MIL-V-2D
 AMENDMENT 3
18 February 1981
 SUPERSEDING
 AMENDMENT 2
 10 August 1973

MILITARY SPECIFICATION

VALVES, CYLINDER, GAS

(FOR COMPRESSED OR LIQUEFIED GASES)

FIGURE 1a. CAP AND PLUG

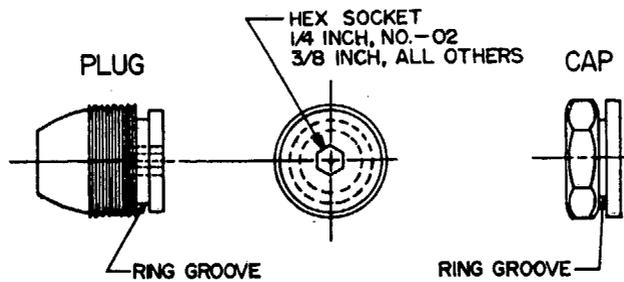
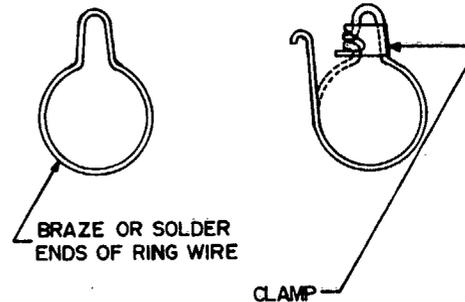
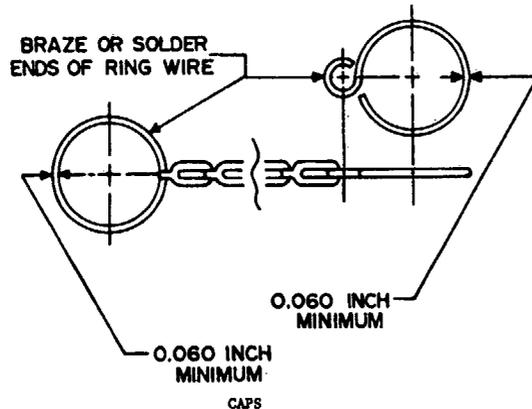
"3.9.8 Outlet cap and plug. When specified, valves with threaded outlets shall have a permanent metal mating plug or cap in accordance with figures 1a and 1 b. The metal plug or cap shall be supplied with retaining chain and clip to secure the plug or cap to the valve. The metal plug or cap shall effectively seal the valve against leakage when tested as specified herein."

3.9.8.1, line 8, delete period after "threads" and add: "in accordance with figures 1a and 1b."

3.14.1.1, at end of paragraph delete the period and add: "except the outlet cap shall be supplied with a retaining chain and ring as specified in 3.9.8."
